## Groundwater Transfer Review Summary Form

Transfer/PA # T- 12919 (RA)

Application: T-12919

Applicant Name: John Bierly

### Observation Well Data

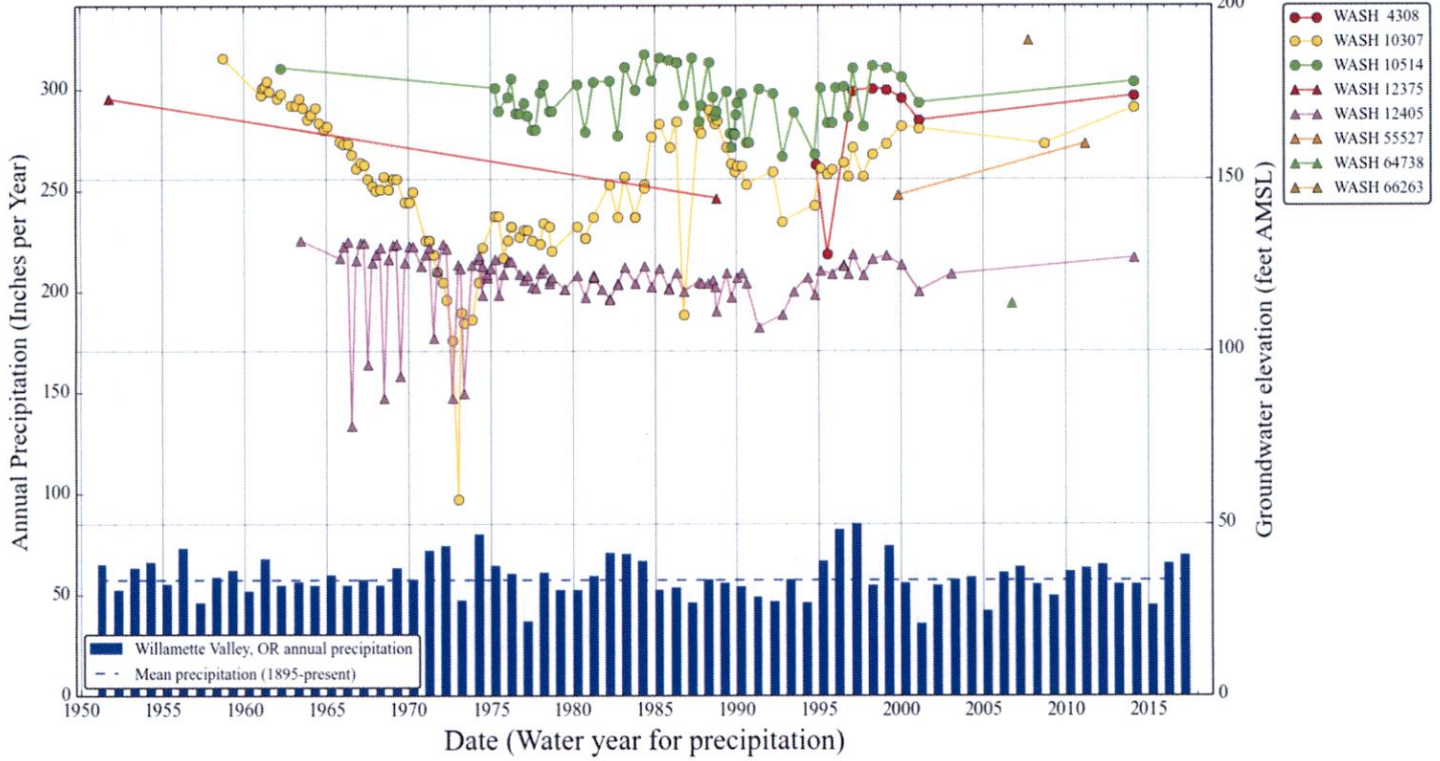
Furthermore, extensive municipal ASR activity in the CGWA over the past 18-20 years has led to increases in aquifer heads, in some instances causing flowing artesian conditions in some domestic wells which required wellhead modifications. Aquifer recharge due to ASR injection is evident from generally-increasing groundwater levels beginning around 2000-2001 (see attached hydrographs). Because groundwater levels in nearby wells are now typically about 20-60 ft bgs, with well depths on the order of 200-500 ft, there appears to be sufficient available drawdown in these wells to mitigate potential interference from this proposed change.
